**AGENDA
CITY OF CEDAR FALLS, IOWA
PLANNING AND ZONING COMMISSION MEETING
WEDNESDAY, JULY 24, 2019
5:30 PM AT CITY HALL**

TO: Planning and Zoning Commission
FROM: Shane Graham, Economic Development Coordinator
DATE: July 17, 2019
SUBJECT: PC-2 District Site Plan Review – 918 Viking Road

TO: Planning & Zoning Commission
FROM: Shane Graham, Economic Development Coordinator
DATE: July 17, 2019
SUBJECT: Highway-1 District Site Plan Review

TO: Planning & Zoning Commission
FROM: David Sturch, Planner III
Matt Tolan, Civil Engineer II
DATE: July 17, 2019
SUBJECT: Park Ridge Estates Final Plat

LAYOUT PLAN

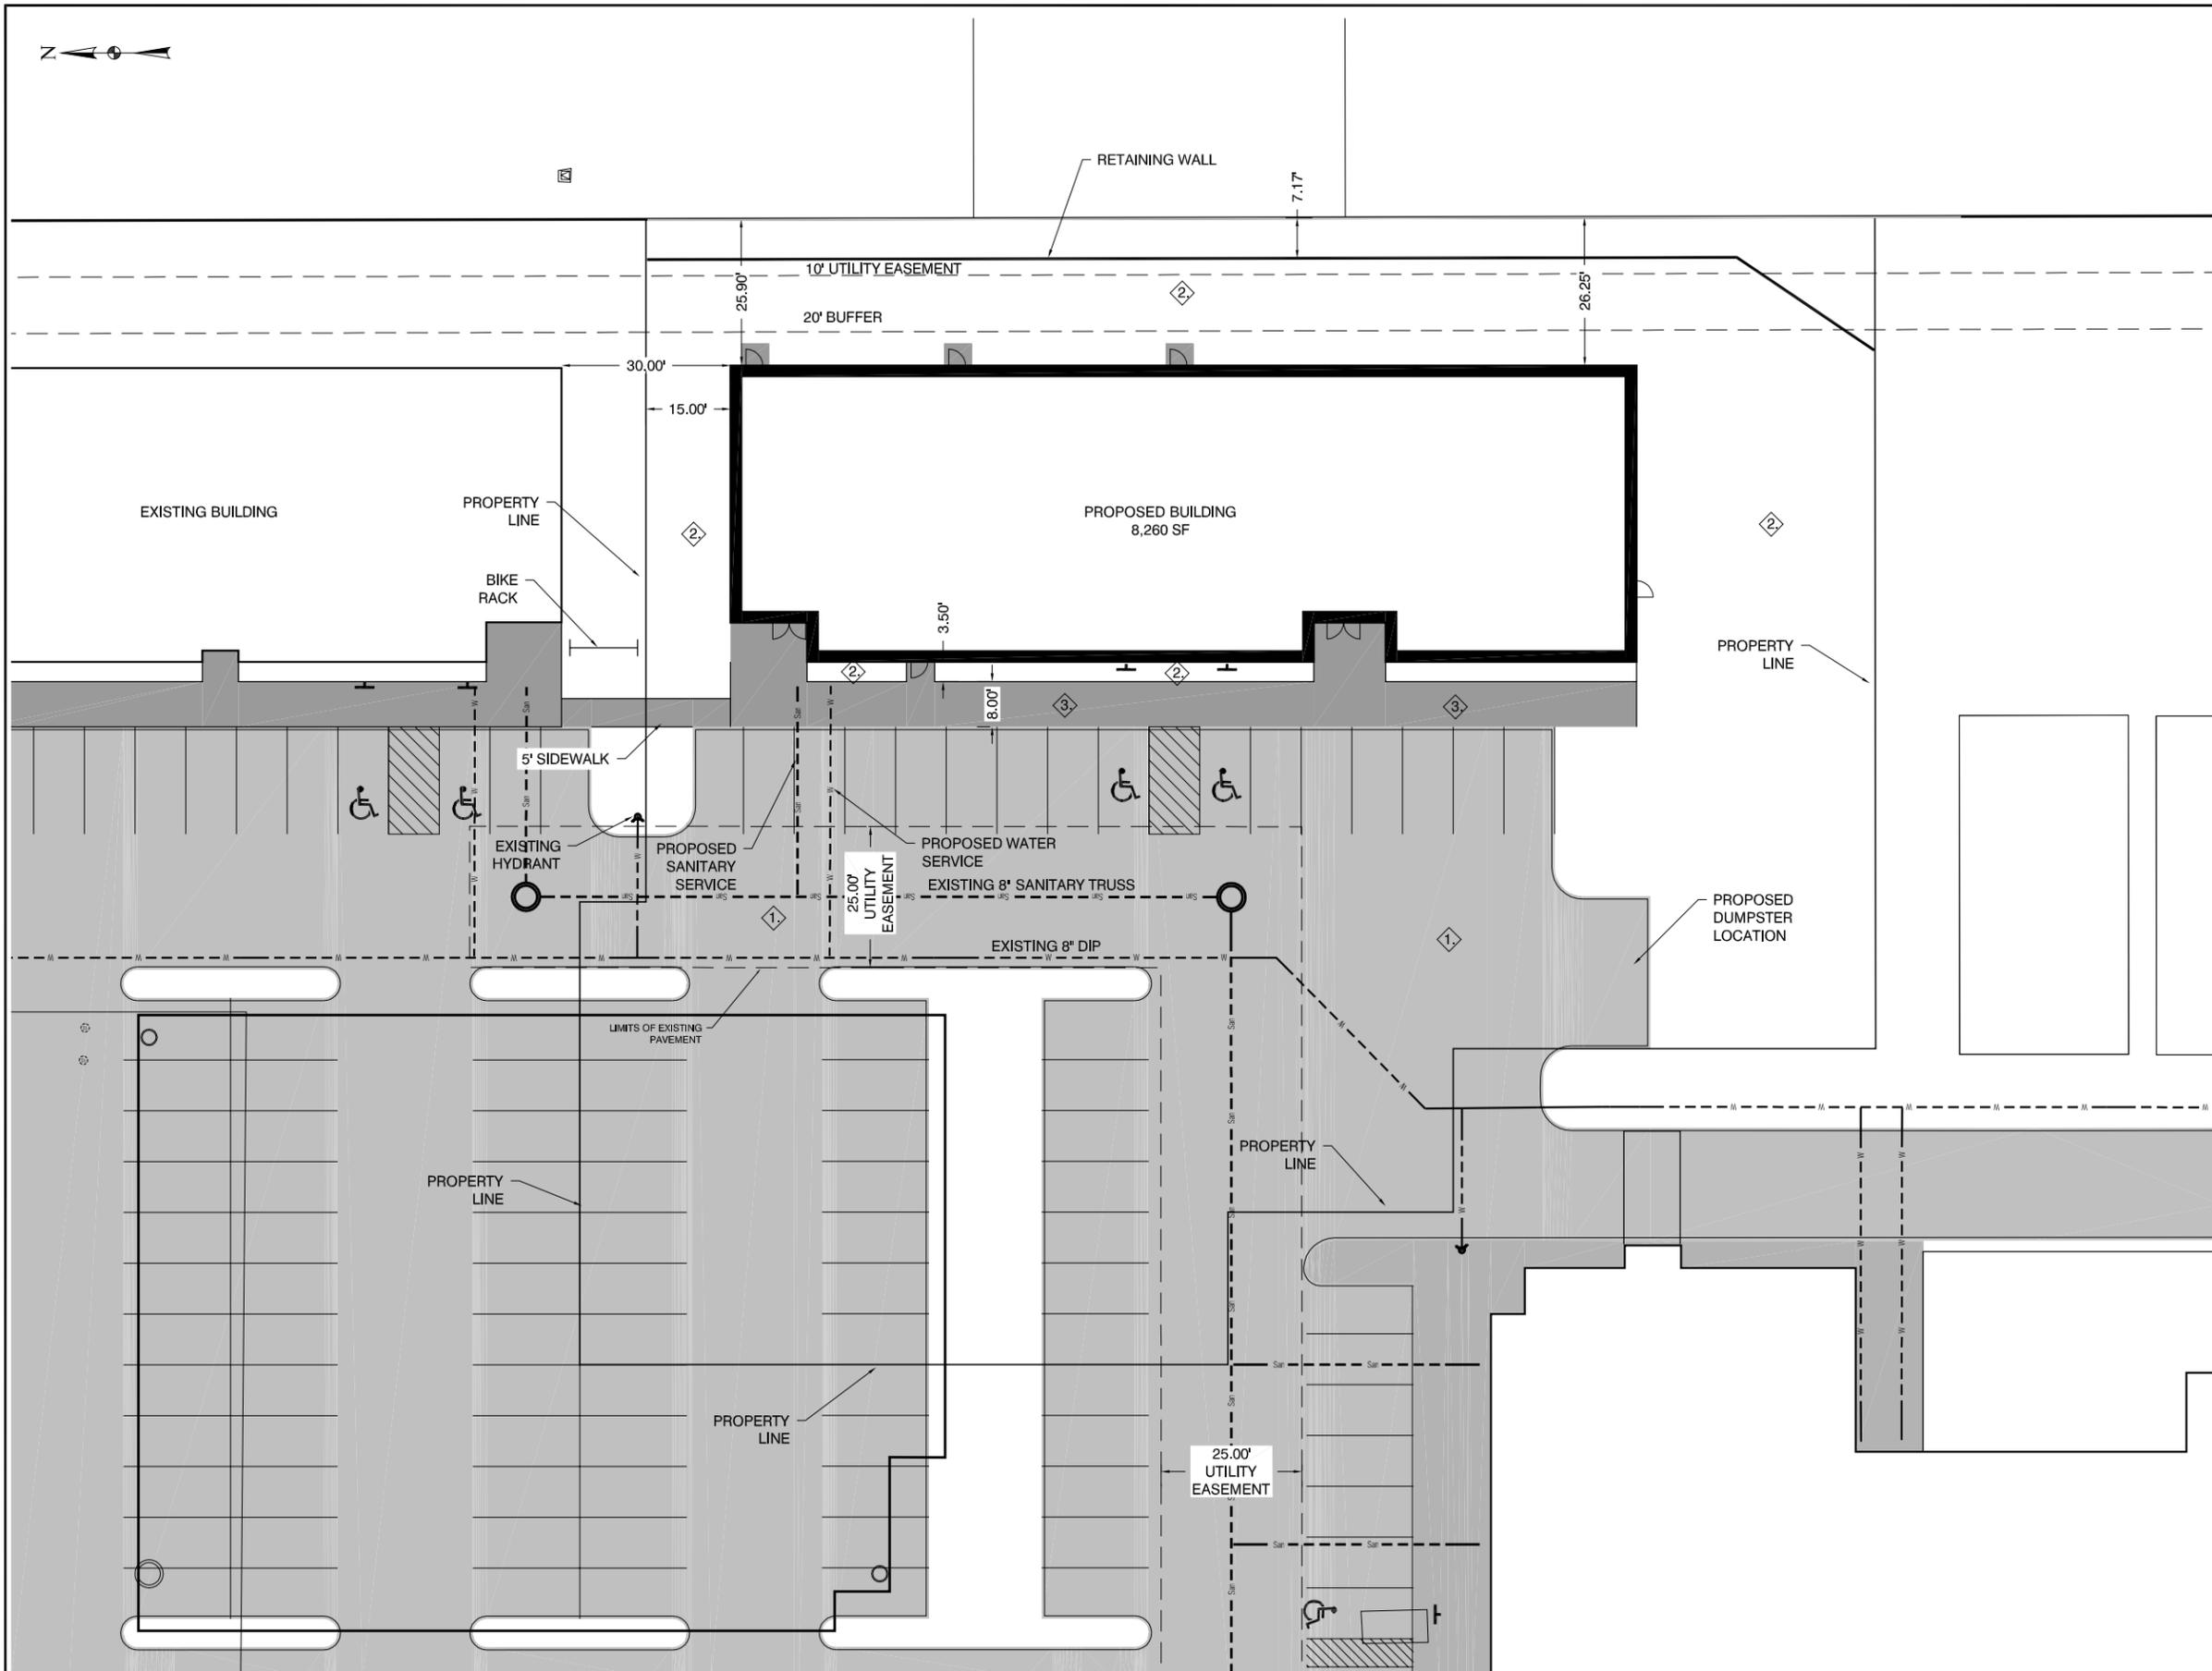
- 1) Proposed Use: The 8,260 square foot retail/professional office building is a permitted use in the PC-2 District. **Use permitted.**
- 2) Setbacks: The setbacks apply to the building, parking lot and signage. The PC-2 District normally requires a 30-foot setback around the perimeter of the "district". The PC-2 District also states that for areas less than 10 acres in size, that the setback area may be reduced to 20', subject to review and approval from the Planning & Zoning Commission and City Council. The developer did ask that the 30 foot open space buffer setback be reduced to 20 feet in width, which was approved by City Council.

The proposed building is located 25 feet from the rear property line, which meets the 20 foot minimum buffer requirement. The parking area is also shown approximately 50 feet from the south property line as well. **Building and Parking Area setbacks are satisfied.**

- 3) Parking: The parking requirement was previously calculated for the entire development, which included the gymnasium building and 4 outbuildings. Based on the anticipated uses and sizes of the buildings within this shopping center, the total parking required for all of the uses is 340 parking stalls. The overall site plan showed 346 parking stalls, which meets the minimum requirement. For this parcel alone (918 Viking Rd), 37 parking stalls are shown. There is a shared parking agreement between the individual parcels that allow for shared parking between the properties. **Parking requirements are satisfied.**

- 6) **Sidewalks:** A Sidewalk is identified along the building frontage. This sidewalk will connect this building to the building to the south, which will connect to the sidewalk that will be installed along Viking Road. **Sidewalk plan is acceptable, and will be installed in conjunction with the construction of this building.**
- 7) **Building Design:** The proposed building will be constructed with a mixture of rock faced block (gray), Cumaru wood shiplap siding, glass windows and doors, and two tones of corrugated metal paneling (silver and charcoal). Wall signage will also be located above each doorway. This building design is the same as Outbuilding #1 and #3, which was previously approved. **Overall Building Design is acceptable.**

Planting Plan

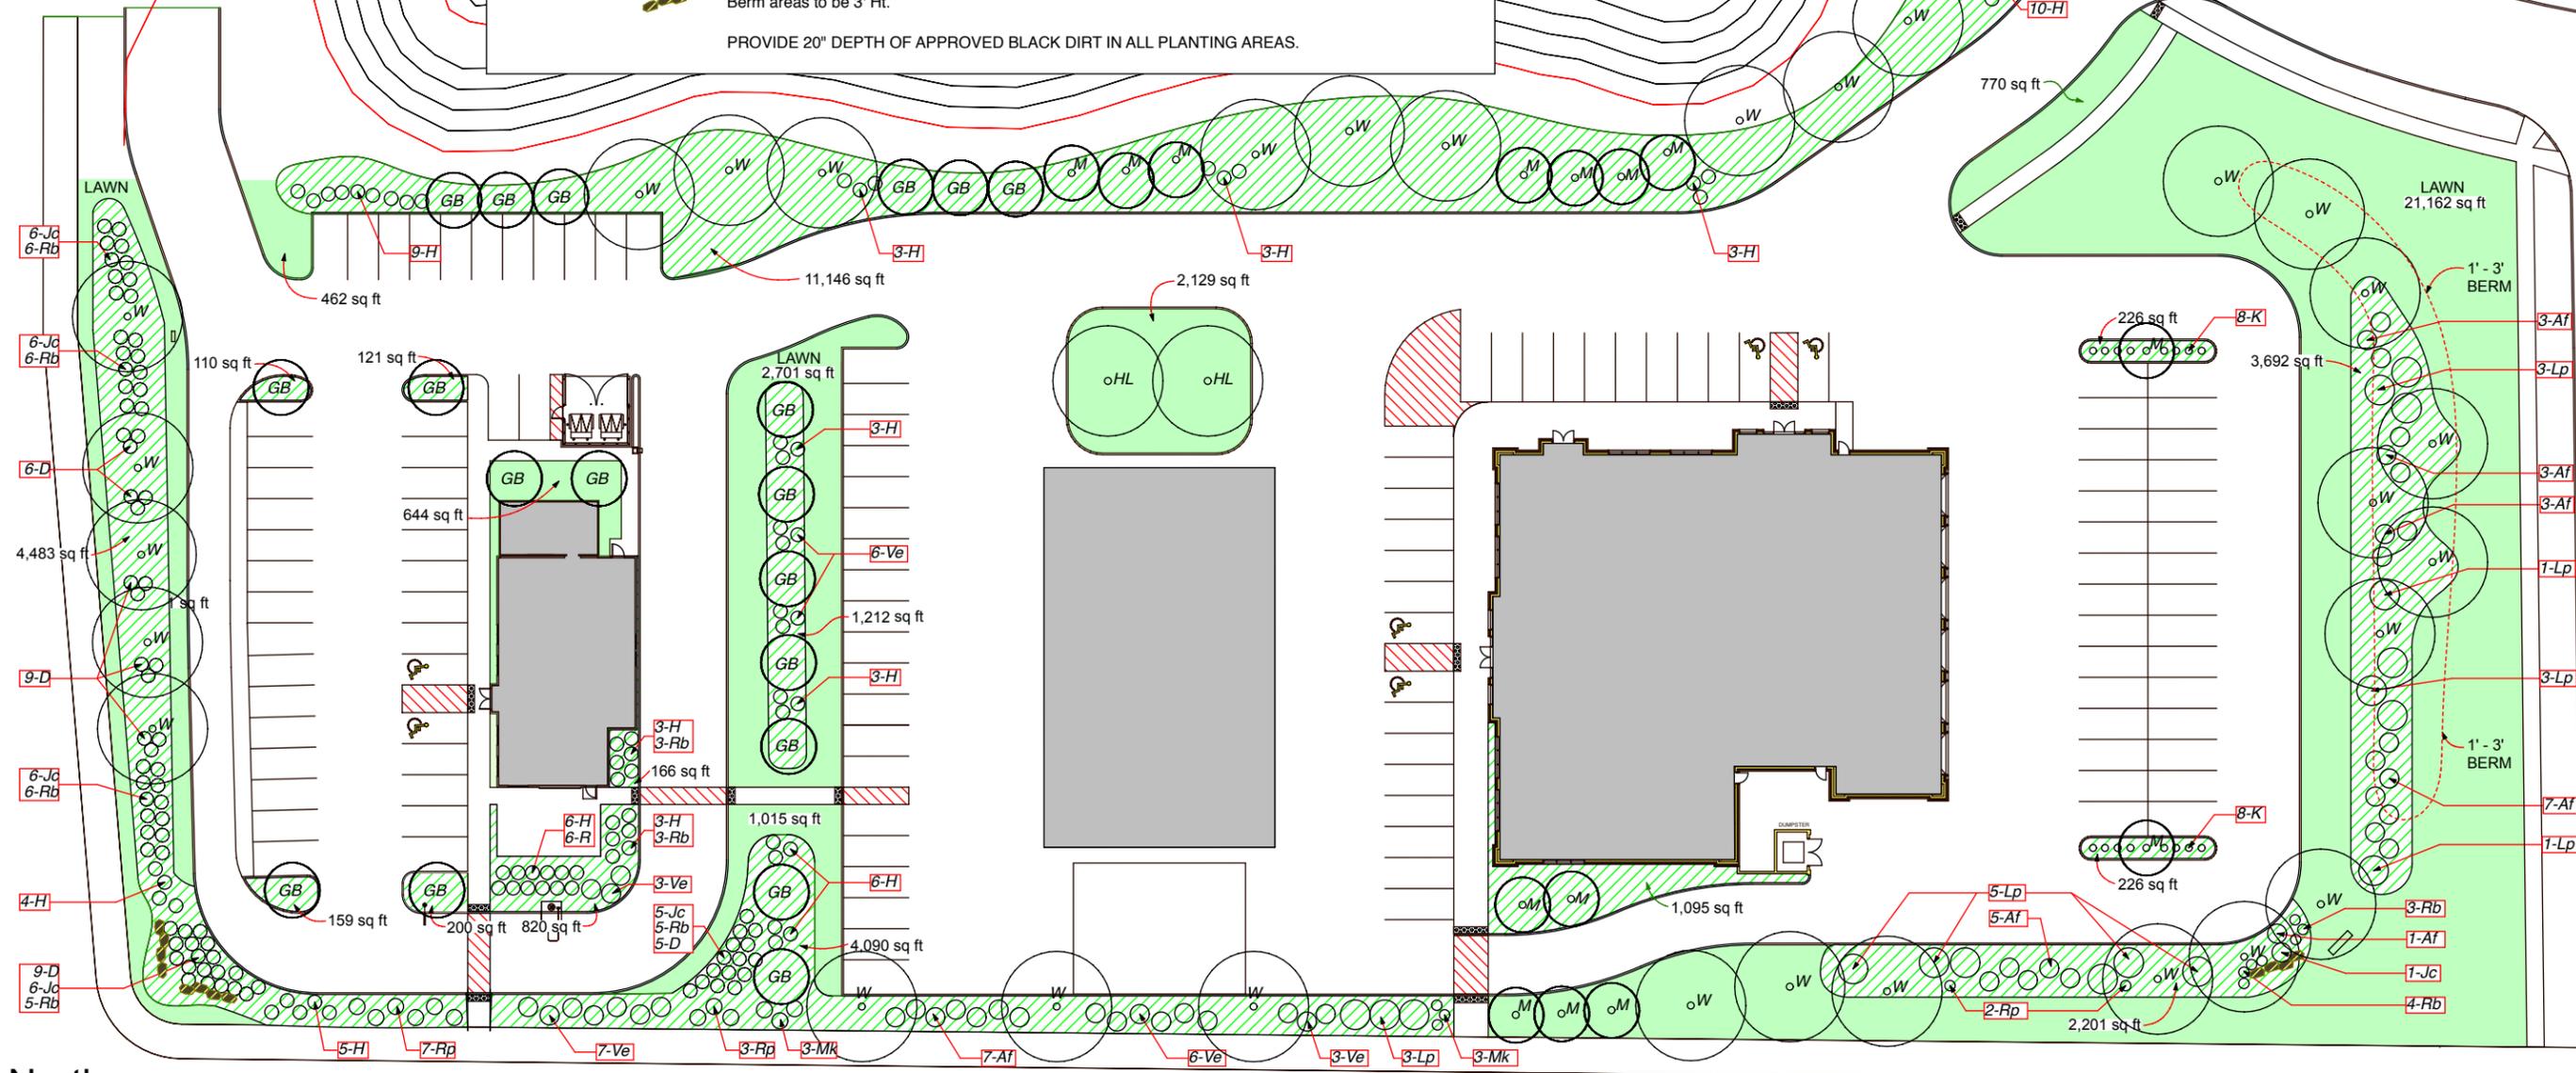
- 5) Landscaping: The previously approved landscape plan showed a total of 8,100 points, whereas the required number of points for the site was 5,446. This landscaping was made up of parking lot trees, street trees, and general landscaping throughout the site. For the updated landscape plan, there are a total of 7,240 points shown, which is 860 points less than the original plan. Although the total number of points has been reduced, the revised landscape plan shows less Karl Forester Grass around the perimeter of the parking area and more hearty shrubbery, which provides more of a screen from the parking lot, but takes up additional space, so less shrubs are needed. Staff feels that this revised plan better screens the parking areas from the roadway, while still meeting the overall landscaping requirements. In total, there will be 64 trees and 259 shrubs and grasses planted on the site. **Landscaping requirements are met.**
